**CONGRUENT SOFTWARE, INC.**  
**98 Colorado Avenue**  
**Berkeley, CA 94707**  
**(510) 527-3926**  
**(510) 527-3856 FAX**

FROM: Peter Johansson  
TO: T10 SBP-3 working group  
DATE: July 15, 2002  
RE: Bare-bones isochronous

**Figure 16 – Normal command block ORB (single data descriptor)**

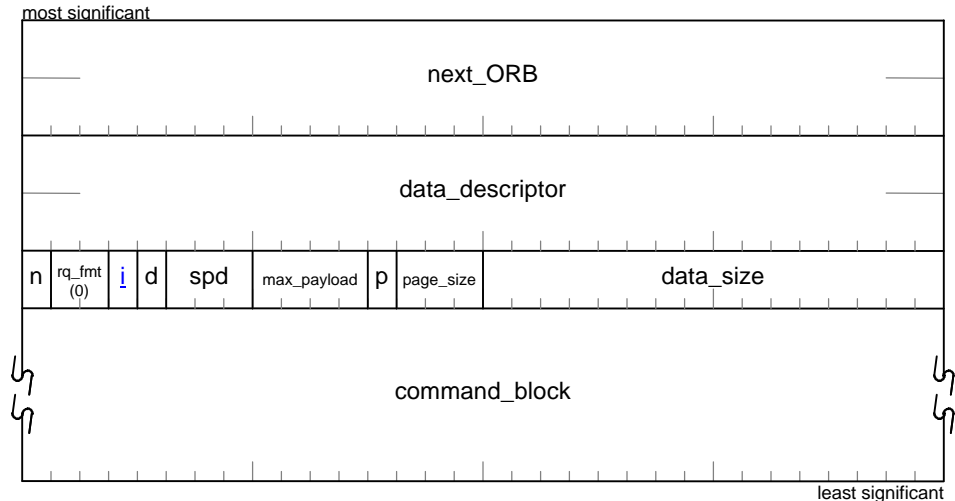
The *isochronous* bit (abbreviated as *i* in the figure above) specifies the transfer method used for data associated with the ORB. When this bit is zero, Serial Bus read or write transactions shall be used to move data to or from the buffer. Otherwise, when *isochronous* is one, data transfer shall be effected by Serial Bus streams, i.e., packets with a transaction code of  $A_{16}$ .

The *direction* bit (abbreviated as *d* in the figure above) specifies direction of data transfer for the buffer. If the *direction* bit is zero, the target shall use Serial Bus read transactions to fetch data destined for the device medium. Otherwise, when the *direction* bit is one, the target shall use Serial Bus write transactions to store data obtained from the device medium.

The *page\_table\_present* bit (abbreviated as *p* in the figure above) shall be zero if *data\_descriptor* directly addresses the data buffer. When *data\_descriptor* addresses a page table, this bit shall be one.

Figure 27 – Create stream ORB

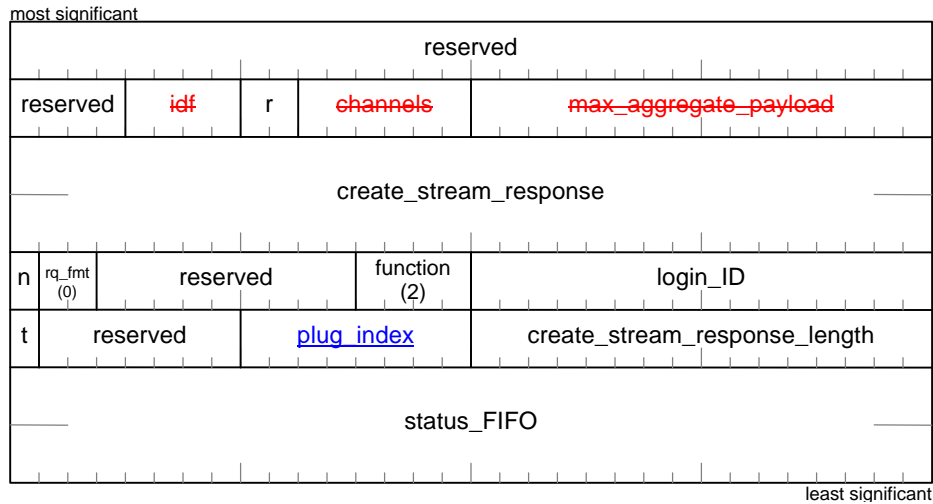
The *talker* bit (abbreviated as *t* in the figure above) shall specify the type of isochronous stream requested. If the target resources are to be configured for listening, *talker* shall be zero.

The *plug\_index* field may uniquely identify a single source or sink or stream data within the context of the target. If *plug\_index* is zero, command set-dependent methods specify the parameters of all stream data. When *plug\_index* is in the range one to 1F<sub>16</sub>, inclusive, it identifies a plug control register that mediates reception or transmission of stream data. The type of plug control register referenced, either an input or output plug control register, is determined by the value of the *talker* bit. Consult IEC 61883-1 for the specification of plug control registers. Other values of *plug\_index* are reserved for future standardization.

**Figure 28 – Create stream response**

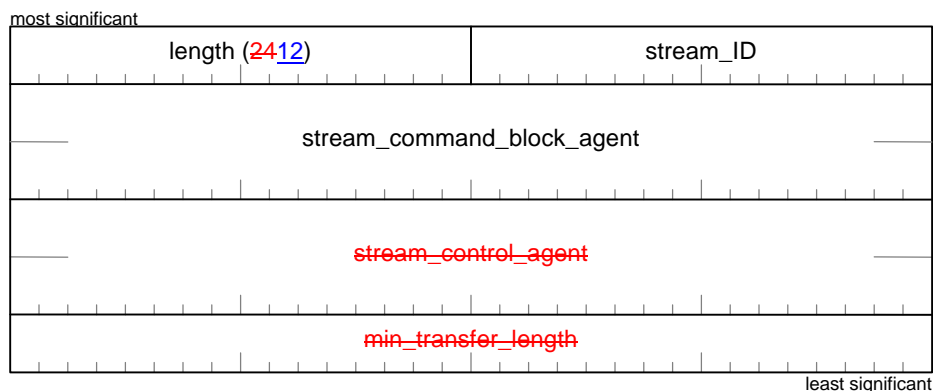
~~The *stream\_command\_block\_agent* and *stream\_control\_agent* fields specify the base address of the agent's CSRs, which are defined in 6.4. Both fields shall conform to the format for address pointers specified by Figure 11. The *node\_ID* portion of either field shall have a value equal to the most significant~~

~~16 bits of the target's NODE\_IDS register. If the target does not implement a stream control agent, the contents of *stream\_control\_agent* are unspecified and shall be ignored by the initiator.~~

~~The *min\_transfer\_length* field advises the initiator of the minimum *stream\_length* value desired by the target in stream command block ORBs in order to sustain the isochronous data transfer rate requested by the login. If the initiator presents any stream command block ORBs whose *stream\_length* value is less than this minimum, the target may experience underflow or overflow in isochronous data while talking or listening at the requested rate. Even if this minimum is respected it is still possible for underflow or overflow to occur.~~
